Contract No. 25022 PP0
Project No's. 10000636
Essex Police Precinct 11 New Addition & Renovations (LEED SILVER CERTIFICATION) -
216 & 222 North Marlyn Avenue, Essex, Maryland 21221
Essex – District 15c7

ADDENDUM NO. 4

DATE: 1/12/2026

SHEET DESIGNATION	CONTRACT NUMBER
AD-102	25022 PP0
	JOB ORDER NUMBER
	PROJ-10000636
	SHEET 76 OF 295
	DRAWING NUMBER
	2025-0967
	FILE NO.: 8 REV. 03/22

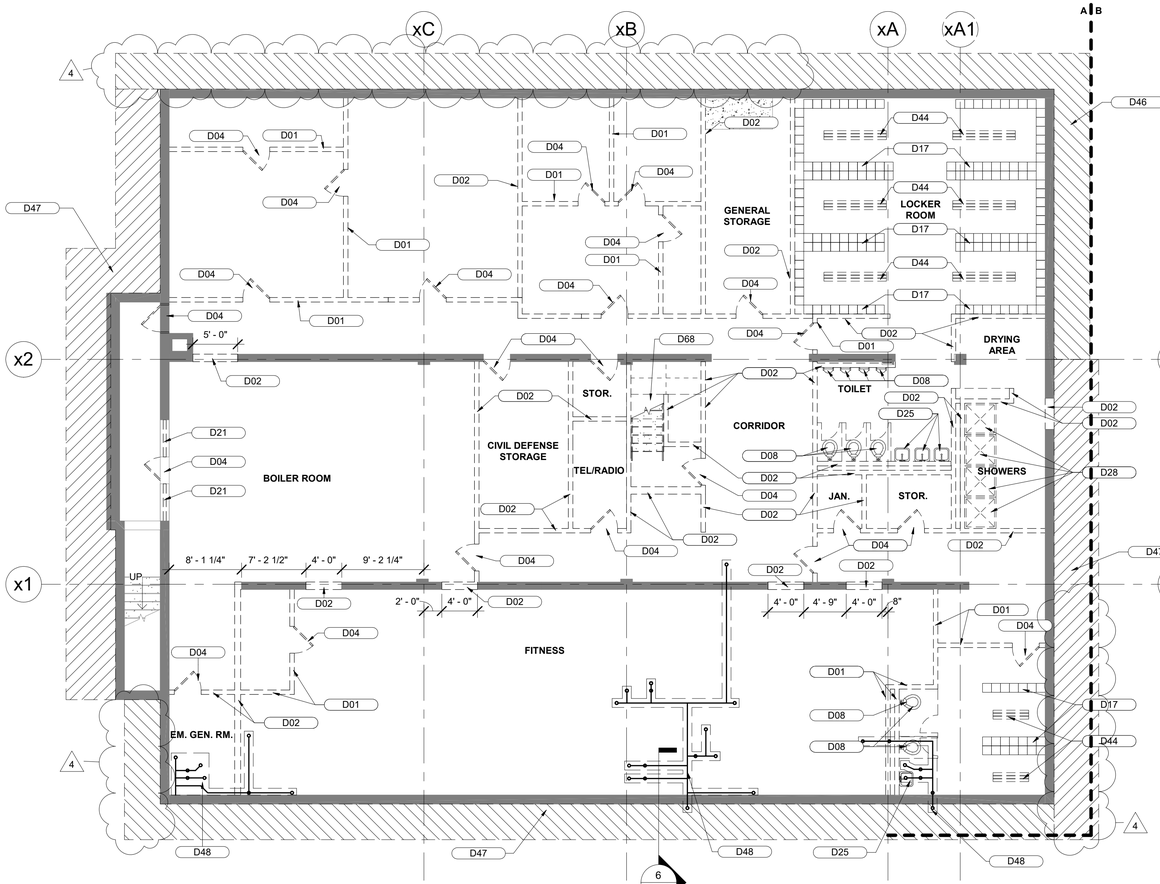
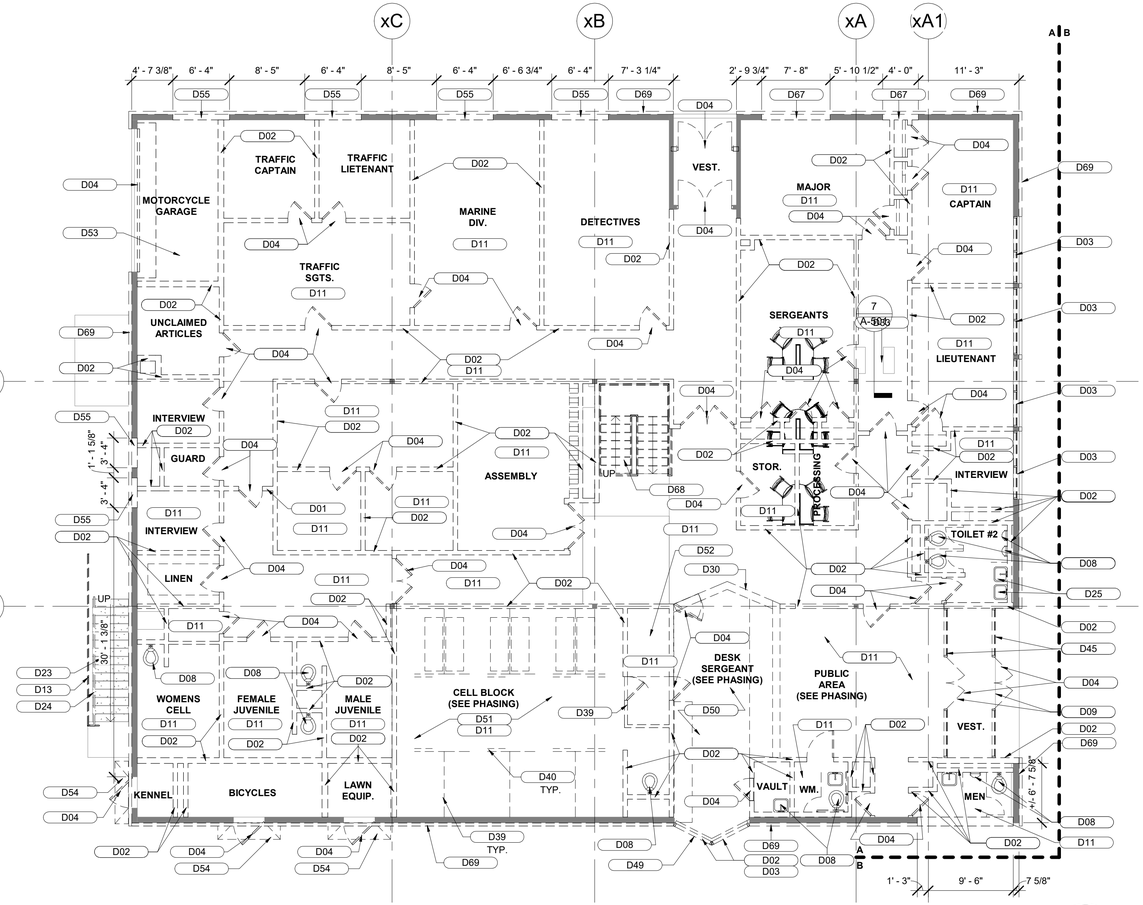
32. Question: *REF: Demo Note #D46 on AD-102. Note #D46 says, "In Phase 1, excavate hatch area to B.O. Mat Slab. Determine condition of the existing drain tile & waterproofing membrane. GC shall hold an allowance to replace the entire perimeter of the existing building's drain tile and waterproofing membrane at below grade walls." What allowance amount is the GC to include for this scope of work? There is no allowance amount stated in the Allowances spec section 012100. Please clarify what Allowance amount the GC is to carry for this scope of work.*

Keynote D46 has been revised along with the plan showing the area of demolition around the existing basement. The project shall include excavation, photo documentation of condition of the basement waterproofing, selective demolition of waterproofing membrane, the demolition of the drainage mat and drain tile for the entire perimeter of the basement. New waterproofing membrane, drainage mat, insulation, and a drain tile shall be provided around the entire perimeter. Intent is to lap a portion of the existing to remain membrane with the new membrane. See attached, revised AD-102 & A-501.

SHEET DESIGNATION	CONTRACT NUMBER
A-111	25022 PP0
	JOB ORDER NUMBER
	PROJ-10000636
	SHEET 88 OF 295
	DRAWING NUMBER
	2025-0979
	FILE NO.: 8 REV: 03/03

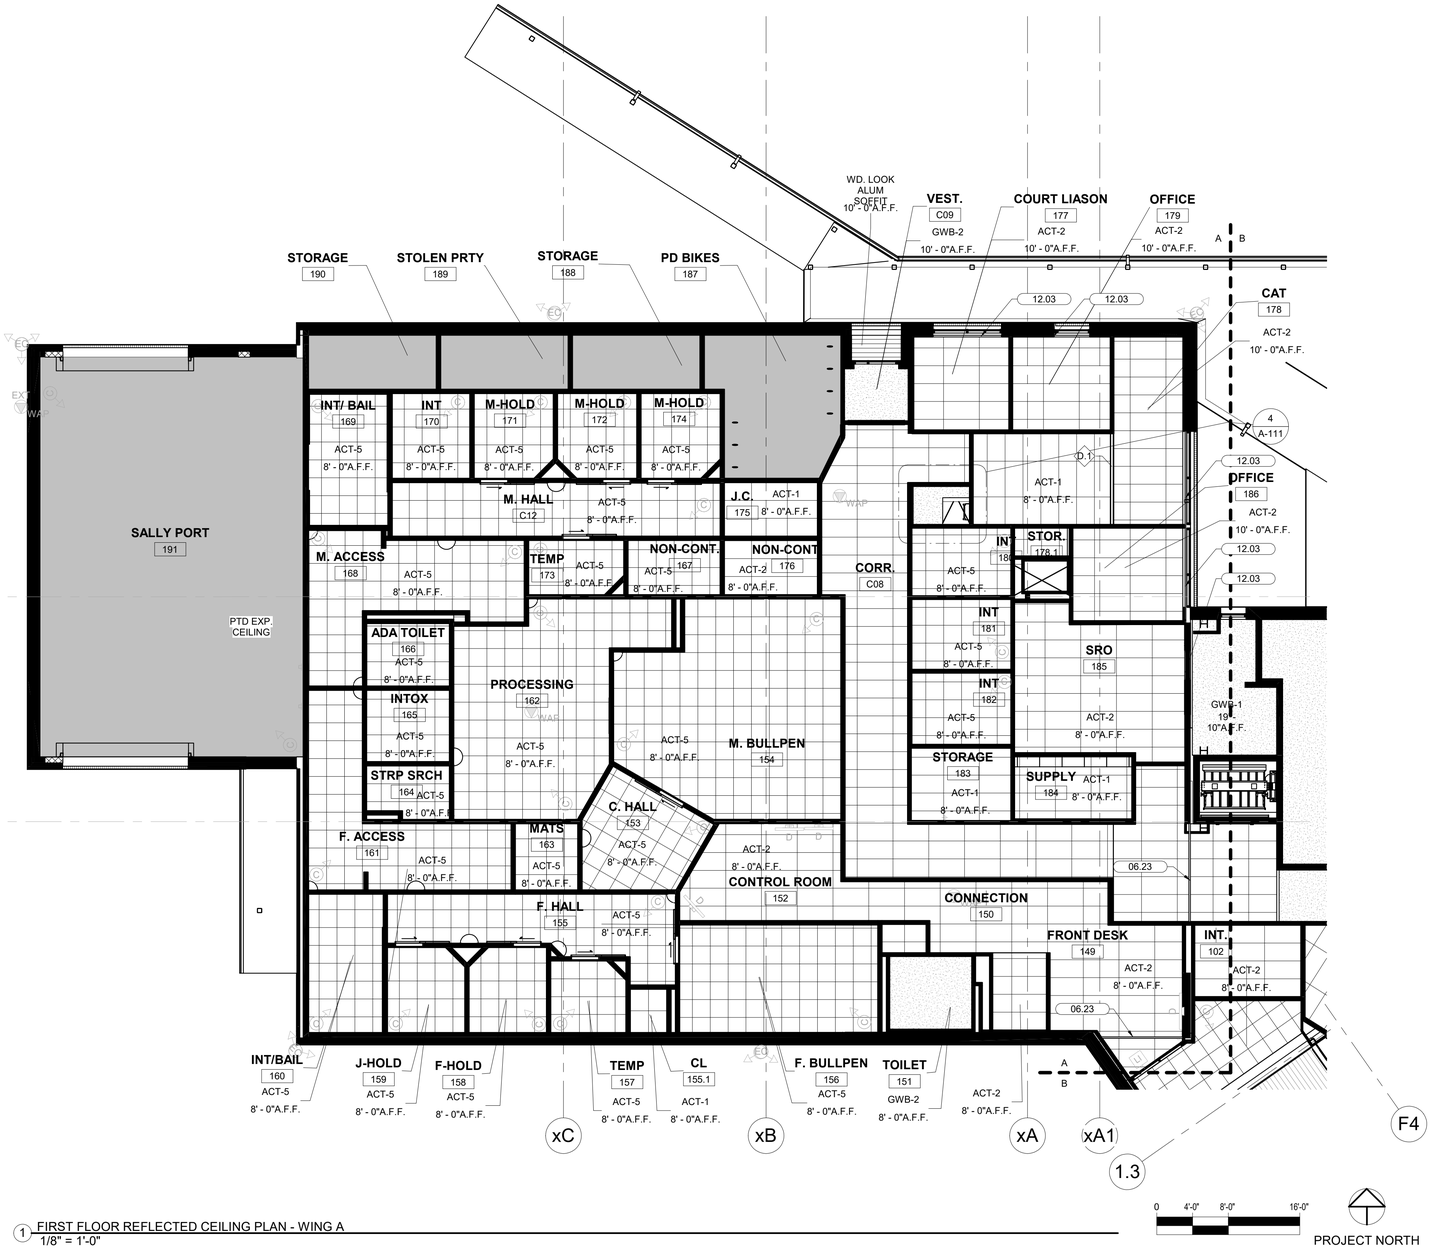
73. ***Question:*** *Sheets 2025-0979 and 2025-0980 indicate shades at exterior windows with Keynote "12.03". Keynote "12.03" is designated as a manual recessed shade. This description of "recessed" conflicts with Details 5&31/2025-1056 which indicate surface-mounted shades which would typically receive fascia. Please confirm mounting conditions for manual shades.*
Response: The roller shades are intended to be surface mounted with a fascia. The keynote 12.03 is revised in the attached A-111 and A112.

KEYNOTE LEGEND	
TAG	DESCRIPTION
06.23	2" CEILING EXPANSION JOINT COVER PLATE.
12.03	TYP. MANUAL ROLLER SHADE (RS-1) ALL EXTERIOR WINDOWS OF THE ROOM.

SHEET DESIGNATION	CONTRACT NUMBER
A-400	25022 PP0
	JOB ORDER NUMBER
	PROJ-10000636
	SHEET 105 OF 295
	DRAWING NUMBER
	2025-0996
	FILE NO.: 8 REV: 03/22

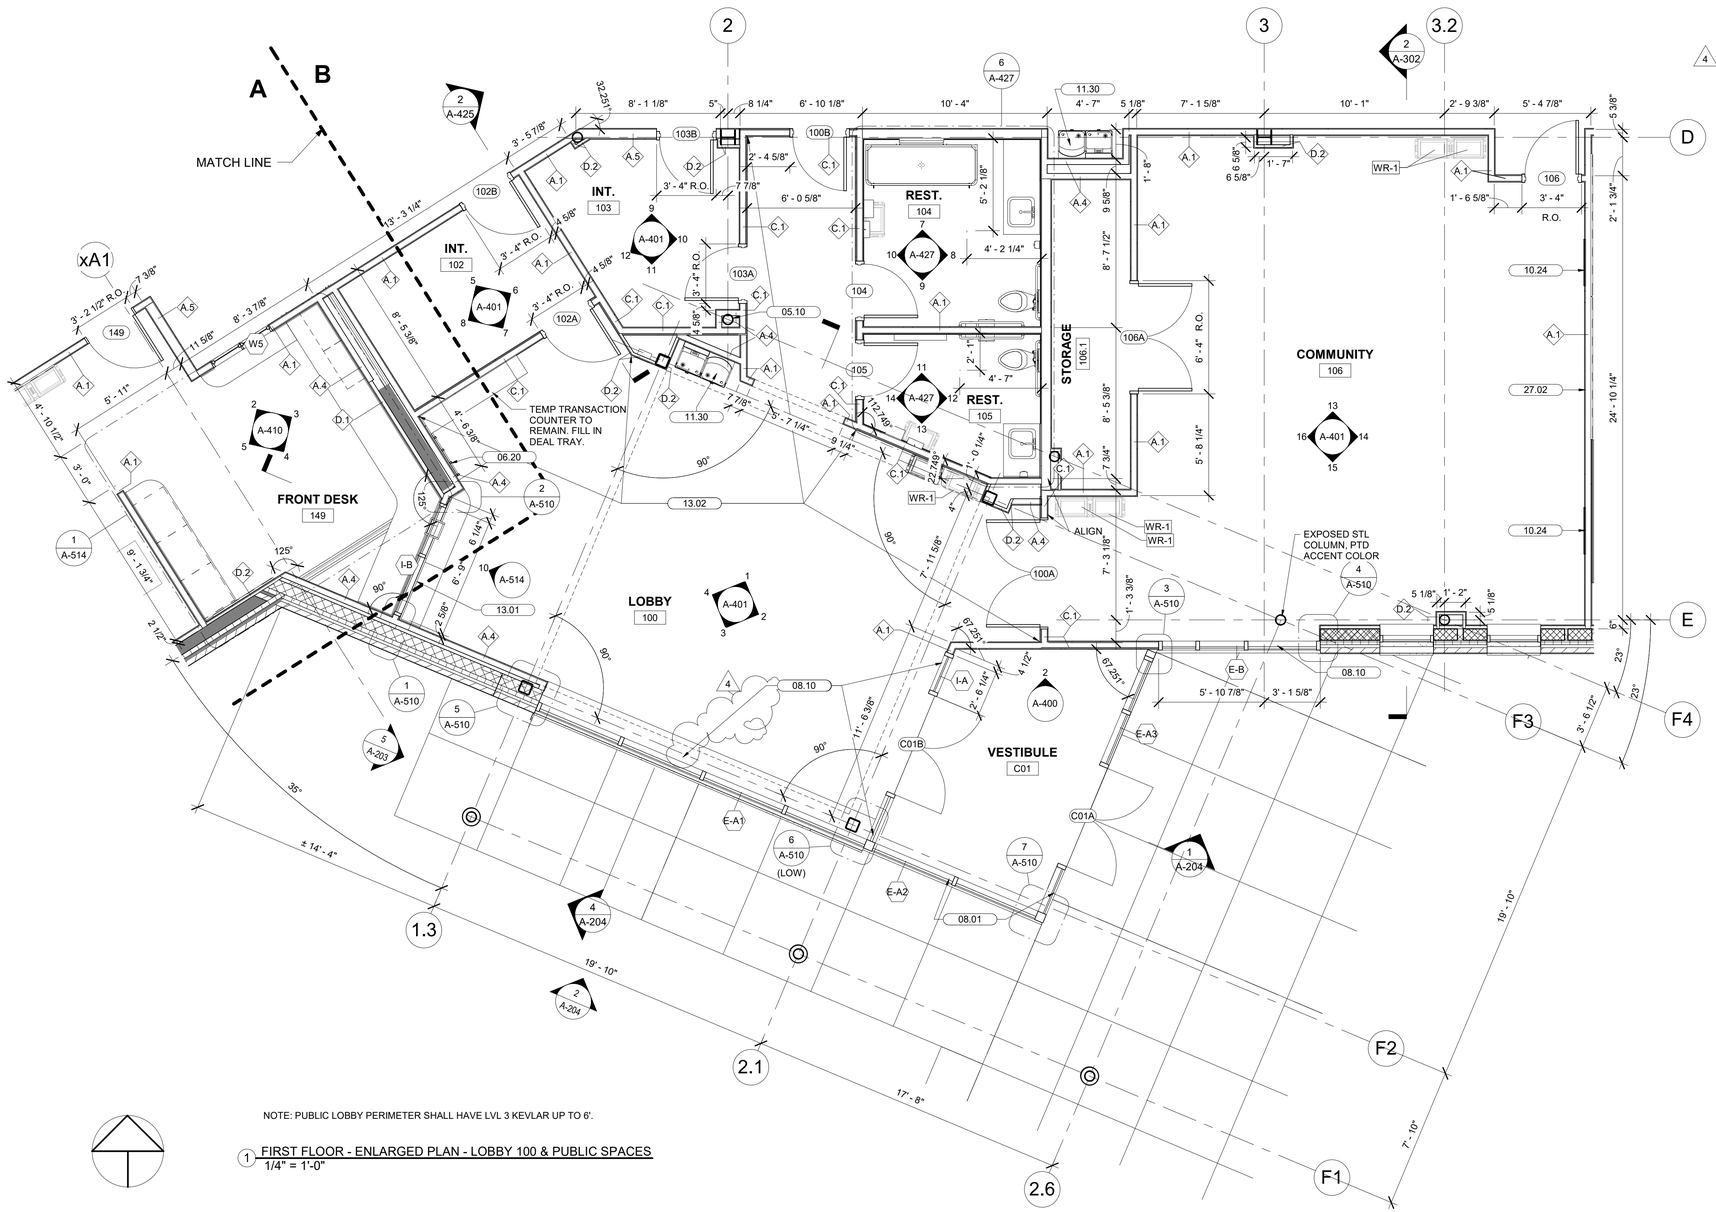
27. ***Question:*** *A-201, A-204, A-400: The floor plans call out much of the Storefront as Level 5 Ballistic, whereas the elevations and some details call all of it Level 3. Add alternate level 5. Is any of the storefront Level 5 the base bid? For example, A-400 calls the Exterior vestibule Level 5, A-201& A-204 call the Exterior Vestibule Level 3, Alt upgrade to Level 5.*
Response: *There is no Level 5 ballistics in the base bid and would only be part of Add Alternate 1. See attached drawing A-400 for keynote revisions related to the ballistic glazing.*

67. ***Question:*** *The floor plans call out much of the Storefront as Level 5 Ballistic, where as the elevations and some details call all of it Level 3, Add alternate level 5. Is any of the storefront Level 5 as base bid? EG. A-400 calls the Exterior vestibule Level 5, A-201 & A-204 calls the Exterior Vestibule Level 3, Alt upgrade to Level 5.*
Response: *There is no Level 5 ballistics in the base bid and would only be part of Add Alternate 1. See attached drawing A-400 for keynote revisions related to the ballistic glazing.*

SHEET DESIGNATION	CONTRACT NUMBER
A-418	25022 PP0
	JOB ORDER NUMBER
	PROJ-10000636
	SHEET 123 OF 295
	DRAWING NUMBER
	2025-1014
	FILE NO.: 8 REV. 10/22

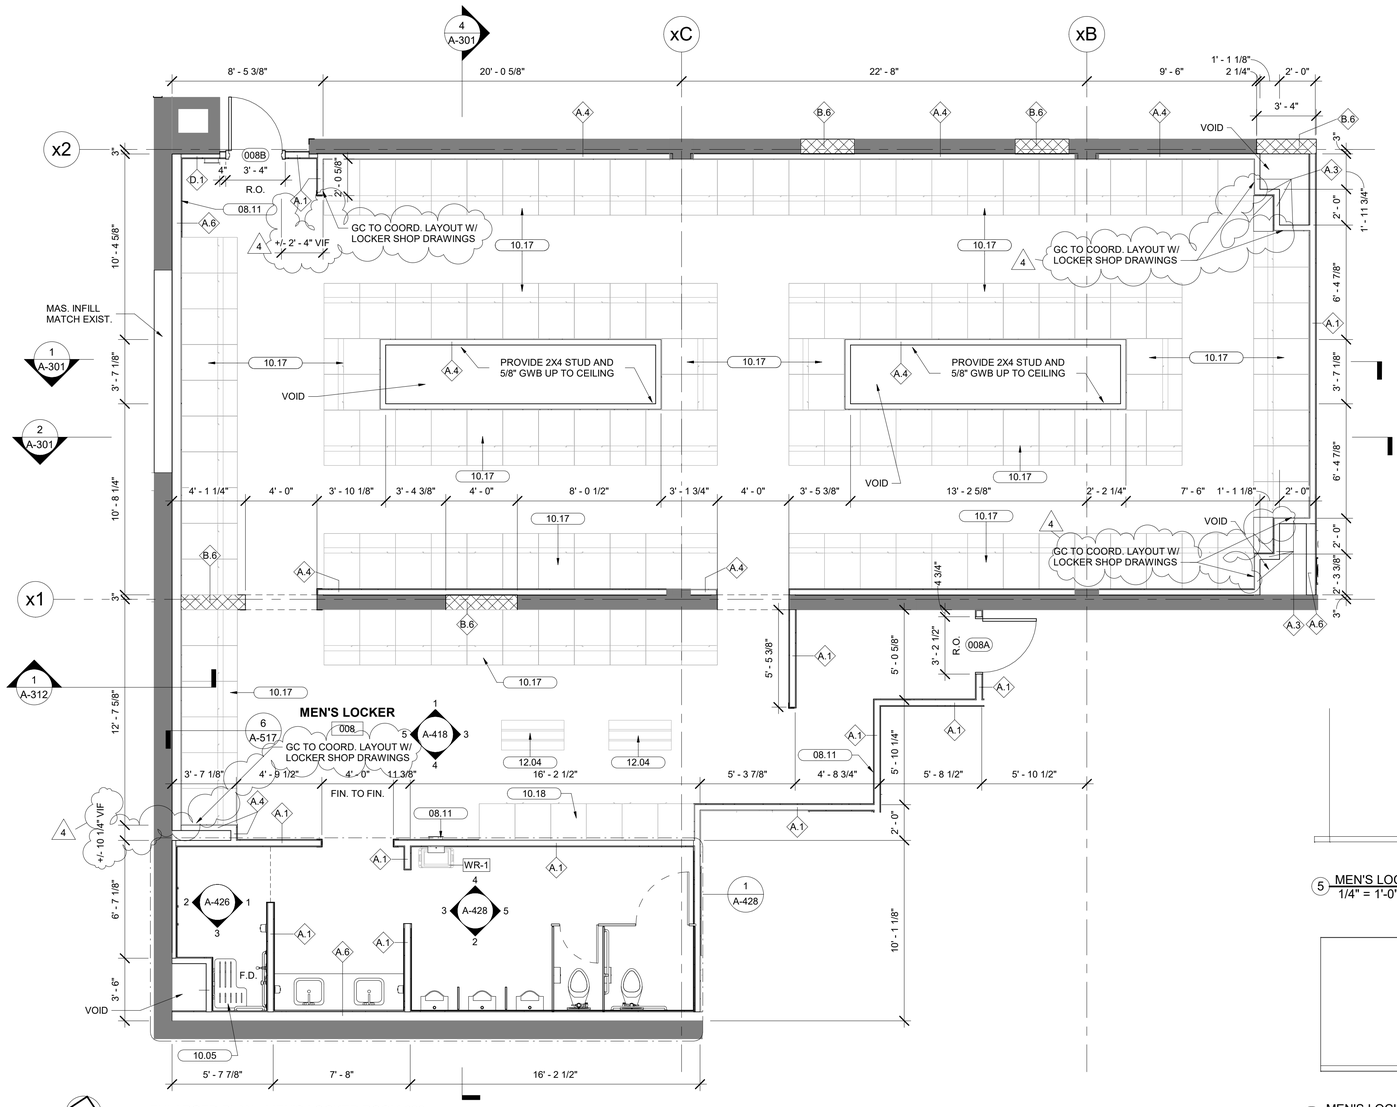
30. ***Question:*** *Will the lockers in the Locker Rooms in the Basement Level have an epoxy base going around the locker bases? If they do have an epoxy base, what would be the height of the locker base?*
Response: *The Lockers do not have an epoxy base.* The entire perimeter of the locker rooms shall have 4" epoxy base. The GC shall coordinate the layout of critical walls with locker shop drawings to accommodate locker MFG. tolerance plus the thickness of the epoxy base. The base will NOT wrap around the lockers. The integral epoxy base is scheduled on A-600. See clarification in revised sheets A-418, A-419, & A-420, attached.

60. ***Question:*** *Is there an Epoxy Base around the locker bases located on the basement level? What is the height of the epoxy base, if so?*
    Response: *The Lockers do not have an epoxy base.* The entire perimeter of the locker rooms shall have 4" epoxy base. The GC shall coordinate the layout of critical walls with locker shop drawings to accommodate locker MFG. tolerance plus the thickness of the epoxy base. The base will NOT wrap around the lockers. The integral epoxy base is scheduled on A-600. See clarification in revised sheets A-418, A-419, & A-420, attached.

3 SECTION DETAIL - UNDERPIN. & STAIR SLAB BELOW GRADE
1 1/2" = 1'-0"

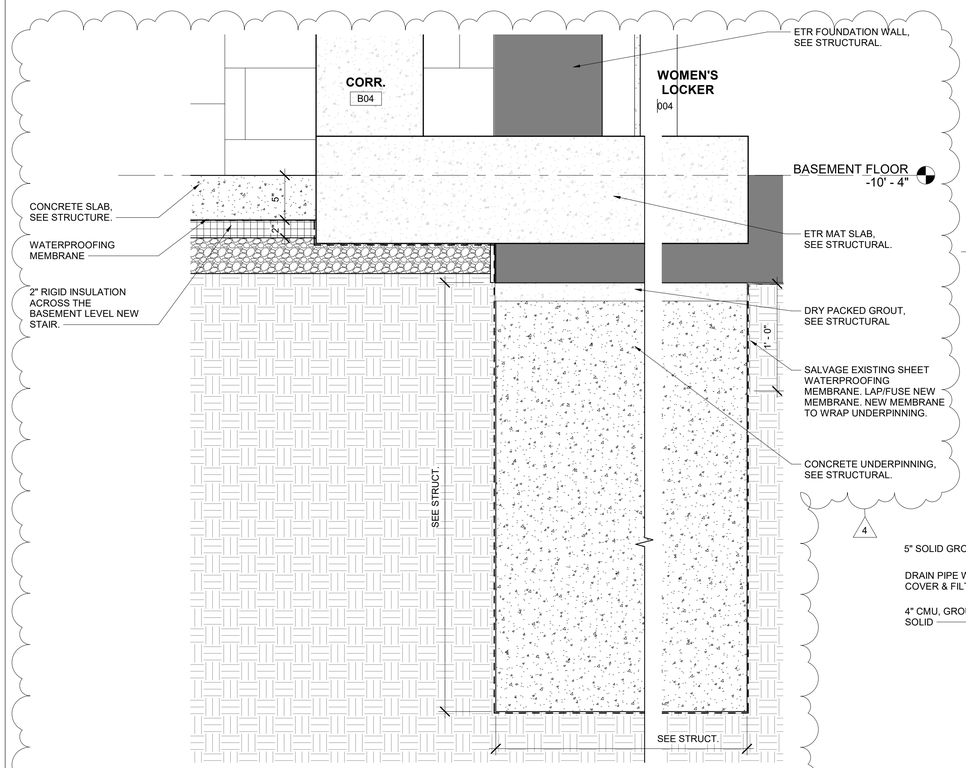
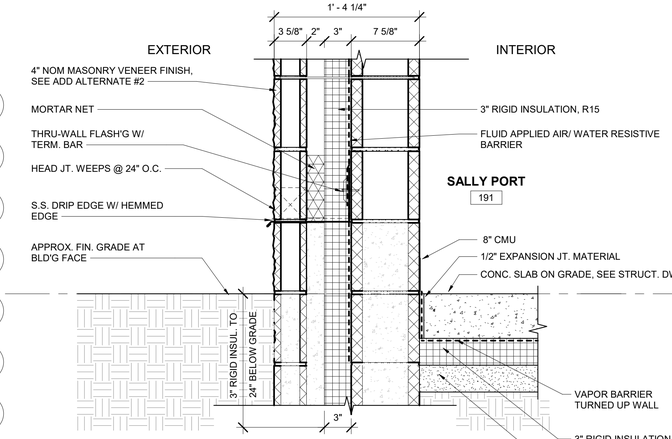
44. ***Question:*** *Please advise us on how we are to waterproof under the existing slab to the underpinning.*
    Response: *See attached revised drawing sheet A-502.*

Revised to show intent of lapping new waterproofing membrane over existing membrane.	
2025-1027	A-502	EXTERIOR SECTION DETAILS – PART B	Addendum #4
		Revised detail 3 to show underpinning waterproofing.	
2025-1038	A-513	PLAN & SECTION DETAILS - STAIRS	Addendum #4
		Revises sheet to add detail 7 Typical Interior Stair Detail. Revises sheet name.	
2025-1052	A-603	DOOR SCHEDULE	Addendum #4
		Revises door panel type, frame type, and detail references for doors 02A, 03, & C09A.	
2025-1138	E304	ROOF PLAN – POWER – WING A	Addendum #4
		Revised to show PVs at Sally Port roof.

SHEET DESIGNATION	CONTRACT NUMBER
E304	25022 PP0
JOB ORDER NUMBER	PROJ-10000636
SHEET 247 OF 295	
DRAWING NUMBER	2025 - 1138
FILE NO.: 8	REV. 0

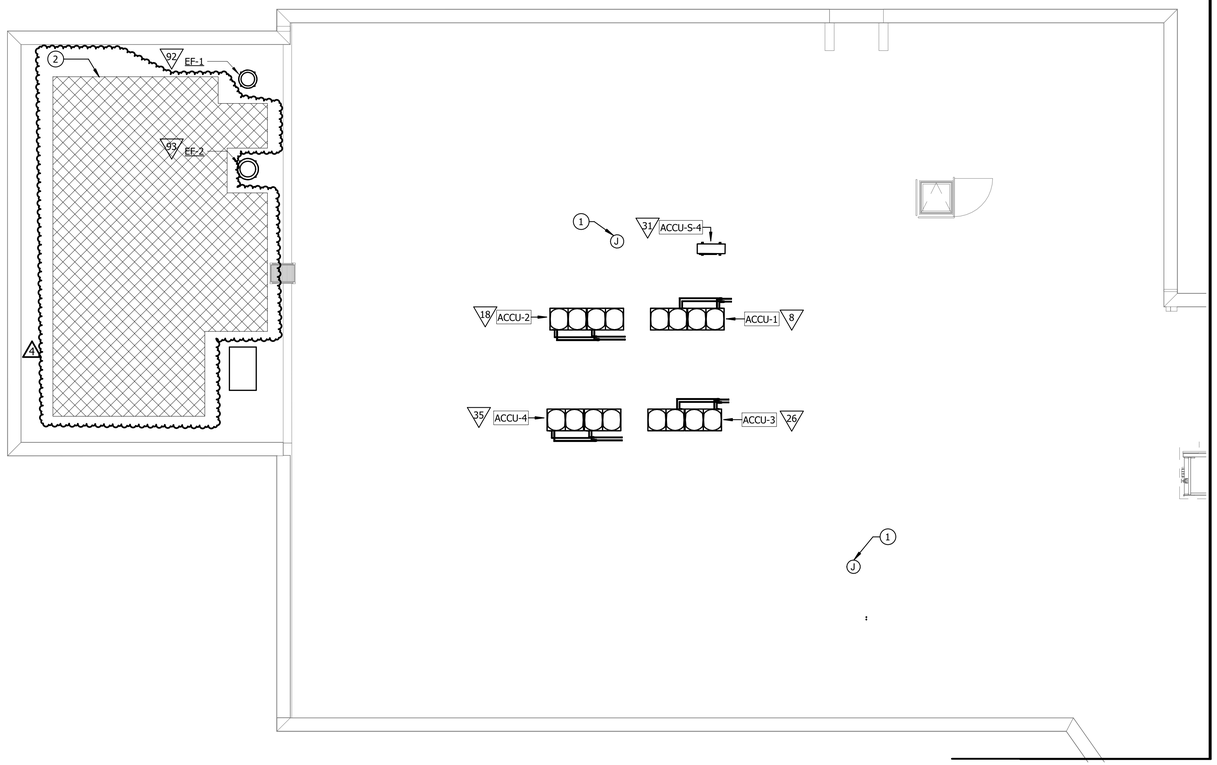
17. ***Question:*** *Drawings A-106 / A-107 show 1,000 SF of photovoltaic panels on the rooftop of Wing A, however on Roof Power Drawing E304 photovoltaic panels are not shown in this location. Please clarify if photovoltaic panels are required at this location per A106 / A107.*
    Response: *T*he PV panels areas does include the roof area above the sally port and will include all components of a photovoltaic system for a complete and operable system. Refer to specifications for additional information about the system. See attached revised sheet E304.
